DEPARTMENT OF MINES  
SOUTH AUSTRALIA

REPORT ON DRAINAGE

PT. SEC. 914 and 915. HD. ADELAIDE.

TOWN PLANNER  
(Re W. C. Emery)

Approved	Passed	Drn.	DRAINAGE INVESTIGATION H <sup>o</sup> ADELAIDE P <sup>ts</sup> 914, 915,  TOWN PLANNER	D.M.	Scale 20 GHNSTO 1"
		Tcd. G.M.		Req.	S3730
		Ckd.			Ha6
Director		Exd.			Date 19.6.64

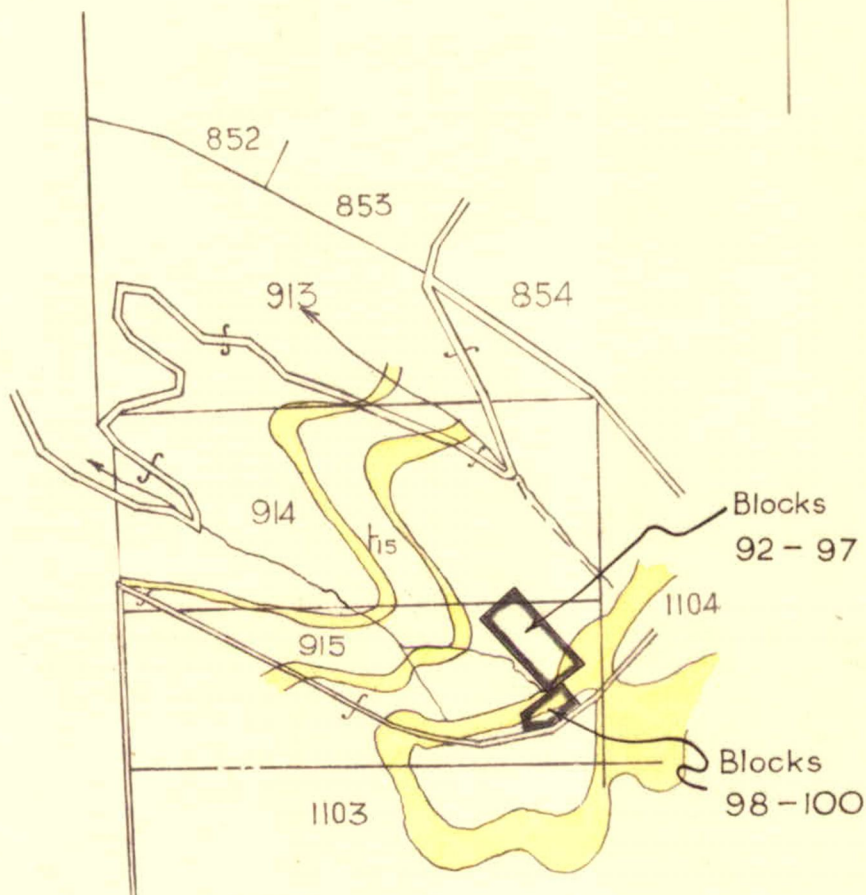
On L.T.O. Plan 7332, new subdivisions are shown which cover the western flank of the north and west orientation spur and the northern slope of the main ridge. The attached geological map shows that the blocks 92 to 97 are underlain by weathered slates which overly a sandstone. Only the southern boundary of block 97 lies on a second sandstone bed.

The upper portion of the slates are weathered and decomposed into clays, which are thin only.

A large quantity of water has to find its way into the underlying weathered rocks. This may cause landslip especially of the thin clayey cover.

In the blocks 98 - 100, sandstones are at shallow depth and, if septic tanks are installed, the effluent would most likely find its way into the underlying sandstones. If, in addition, gardens are established, the excess water may also find its way into the sandstone and thus the danger of landslip on these blocks is believed to be considerably less than on the blocks to the north-east.
